# CENTRALCITY 2035

**Decision Packet G: Willamette  
River - Environment**

**Decision Packet H: Willamette  
River - Open Space and Trails**

PSC Work Session 2 – 11/16/2016

# G1: Landscaping Standard

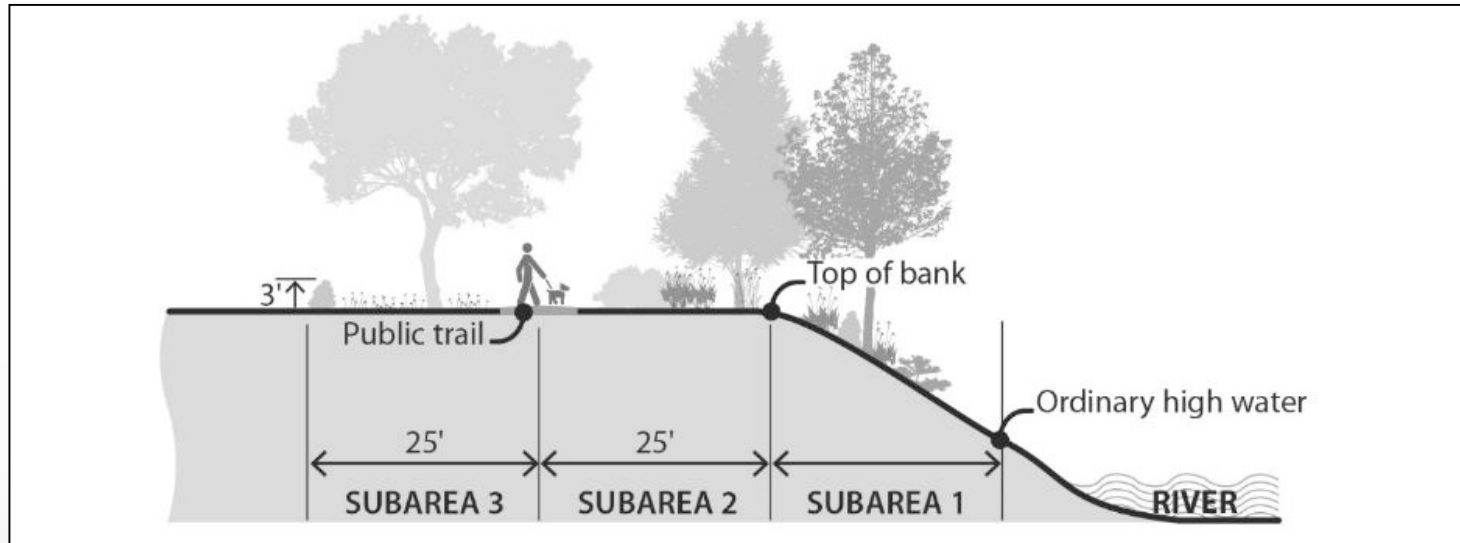
Request 1: No required landscaping on public beaches.

Request 2: Allow flexibility in subarea 1.

# G1: Landscaping Standard

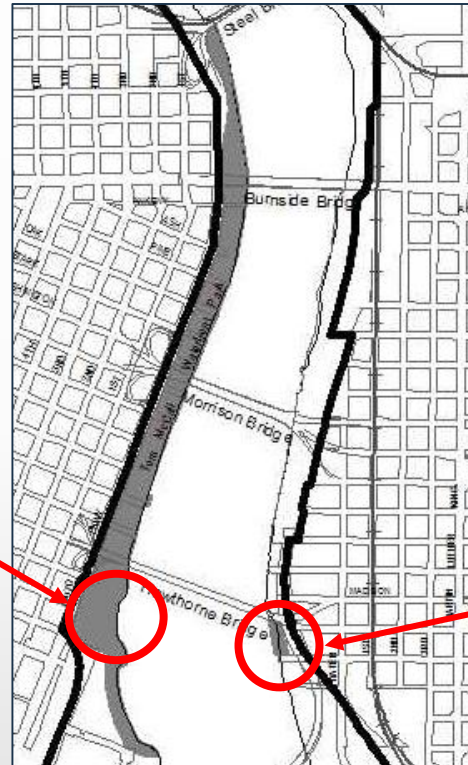
Request 1: Do not require landscaping on public beaches.

Recommendation: Exempt Eastbank Crescent, in addition to Hawthorne Bowl, from the landscaping standards.

# G1: Landscaping Standard

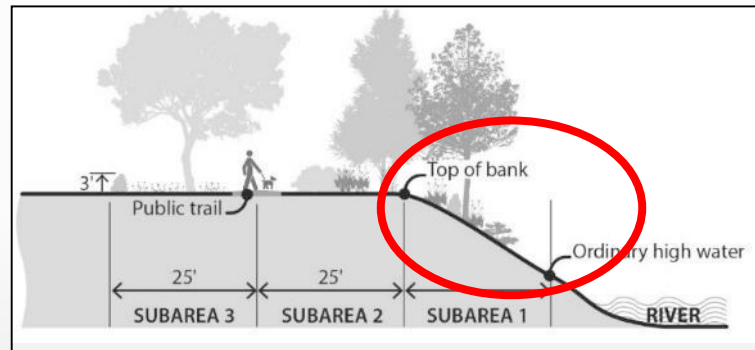
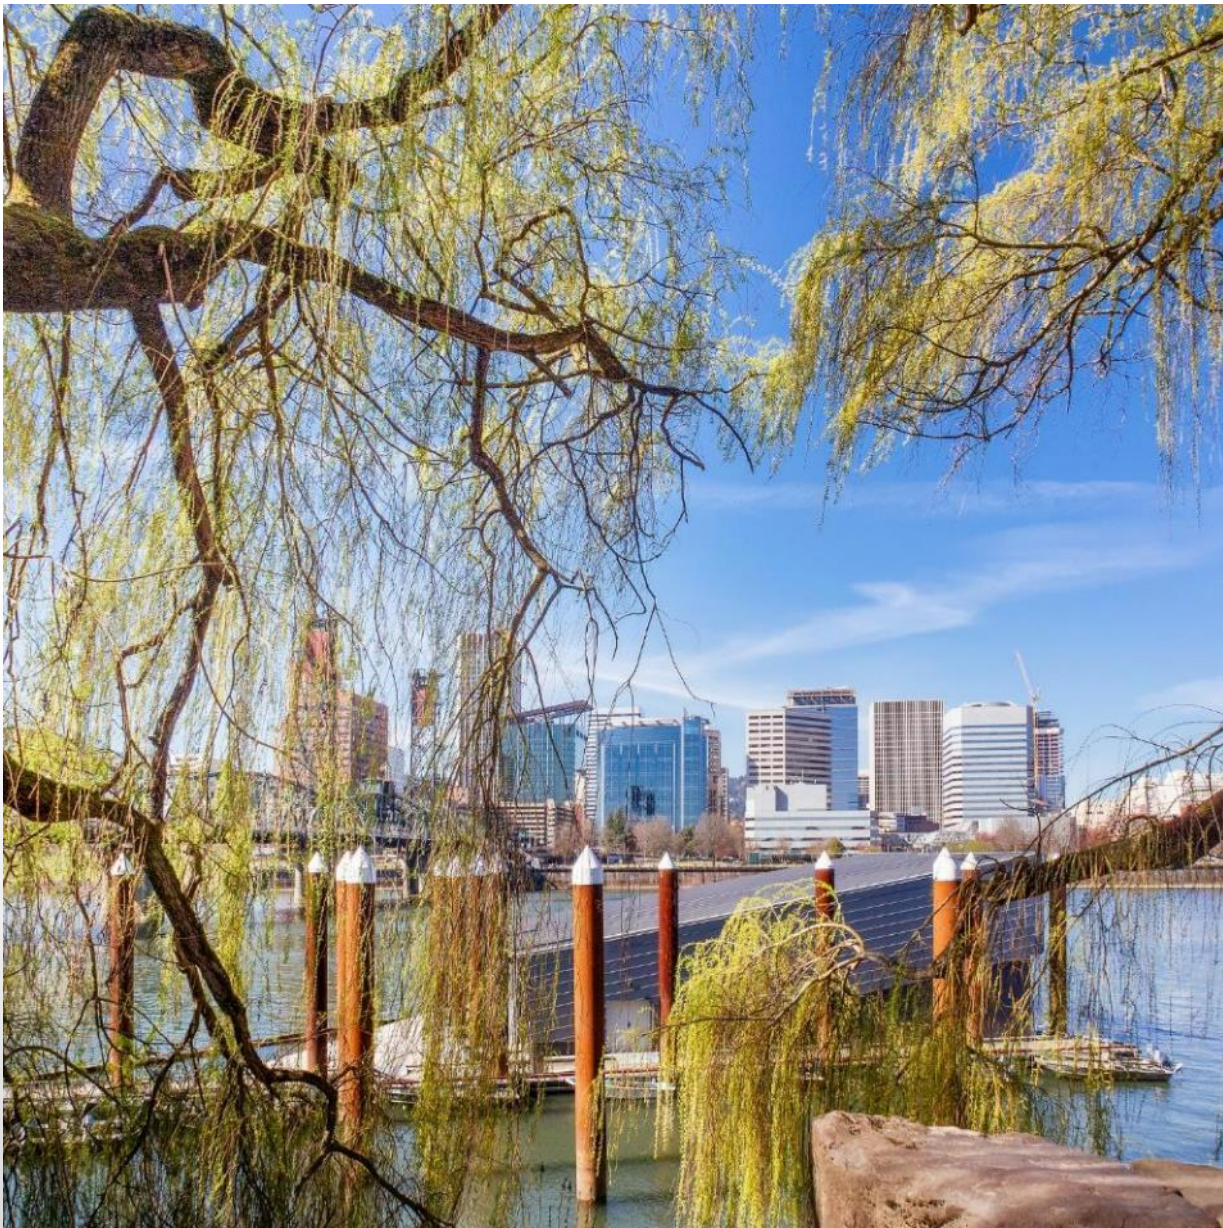
Request 2: Allow flexibility for subarea 1 when it is steep and armored with rip rap.

Recommendation: Allow subarea 1 planting to be done elsewhere on site or pay a fee-in-lieu when the bank is steep and armored with rip rap.

# G1: Landscaping Standard

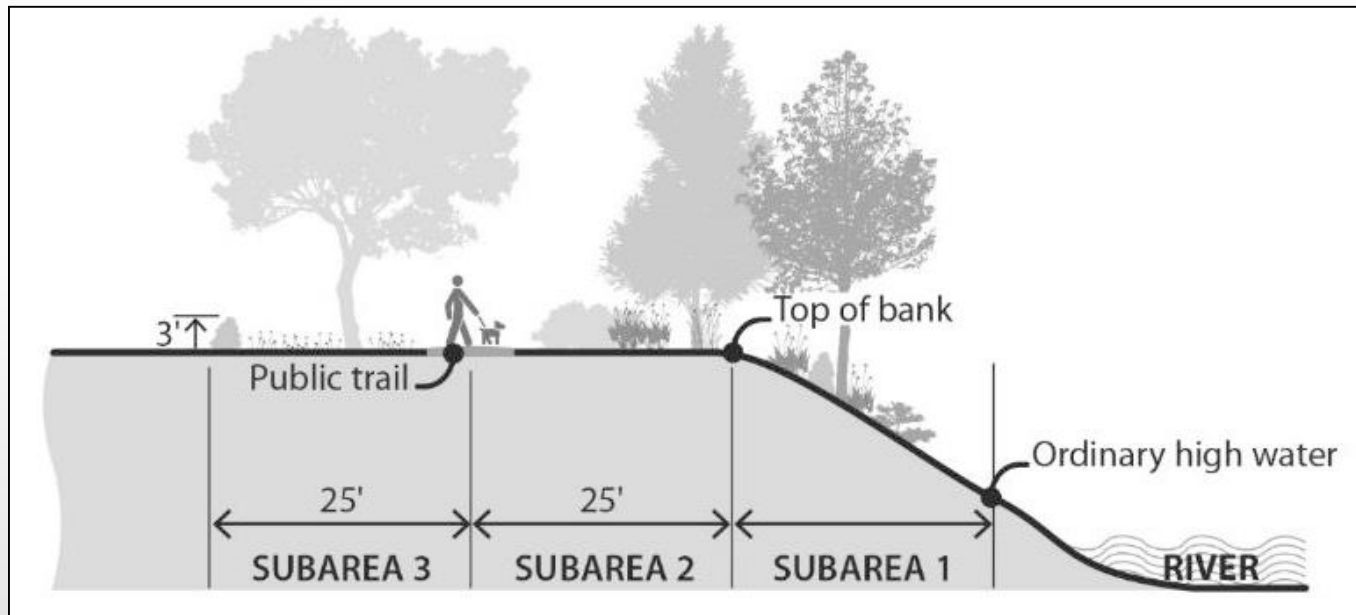
Request 3: Make clear that vegetation planted for resource enhancement, mitigation or contamination clean-up can be counted towards the landscaping standard.

Recommendation: Amend code to clarify.

# G1: Landscaping Standard

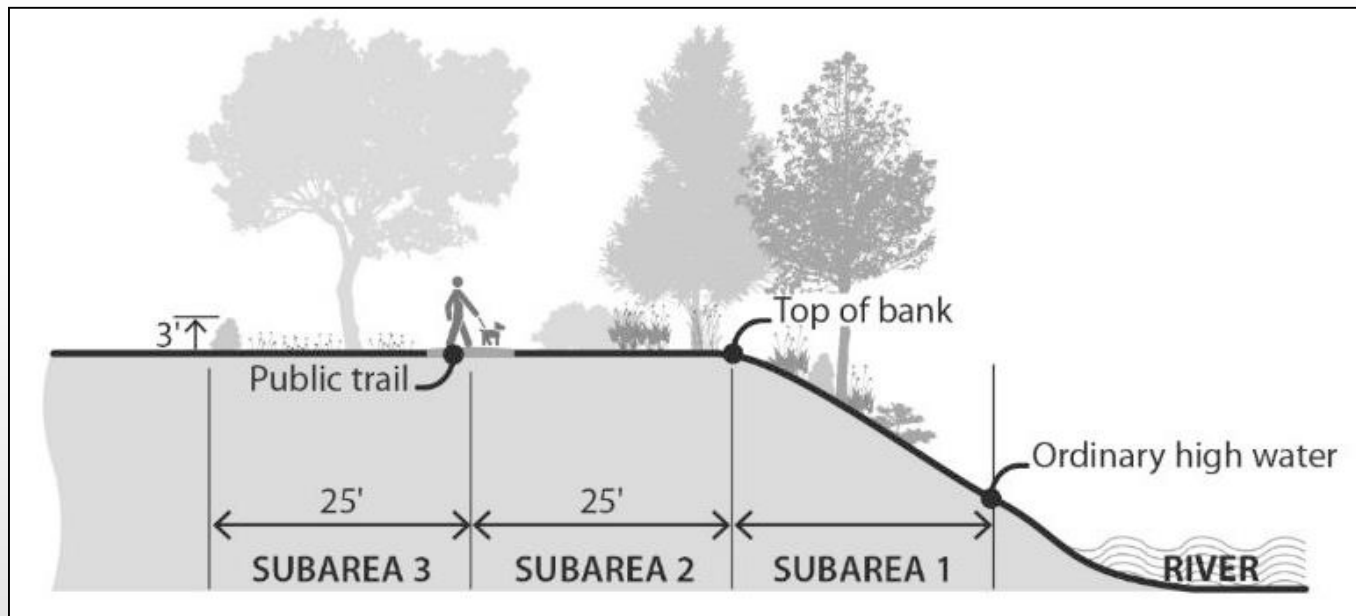
Request 4: Require a specific timeframe for installing the landscaping.

Recommendation: Retain Propose Draft version.

# G3: Encroachment into the Setback

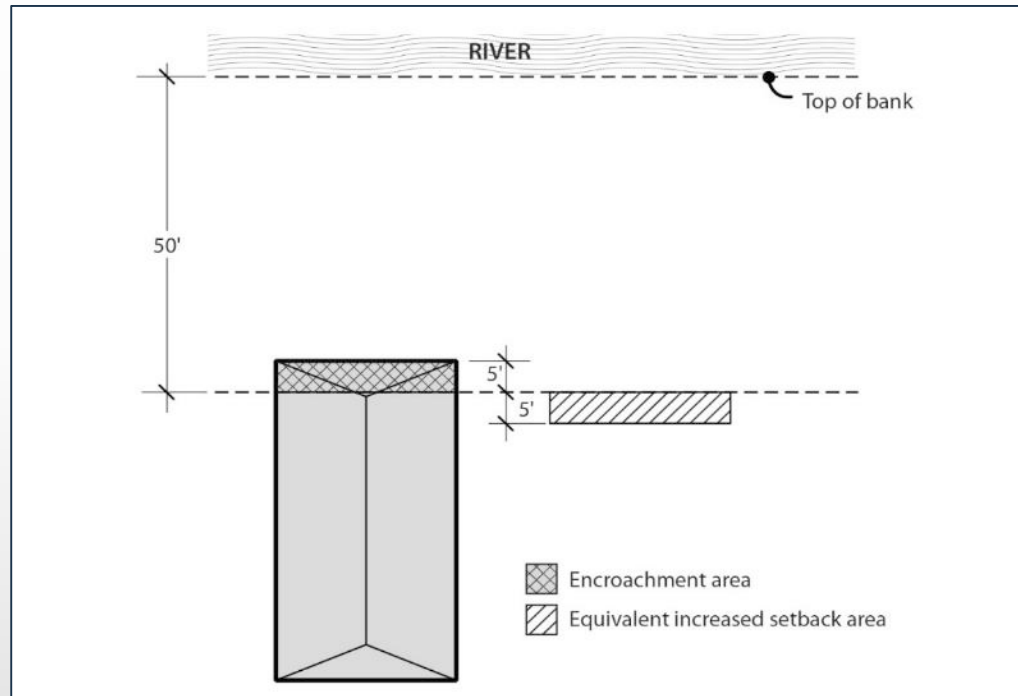
Request: Do not allow encroachment into the river setback.

Recommendation – Retain Proposed Draft version
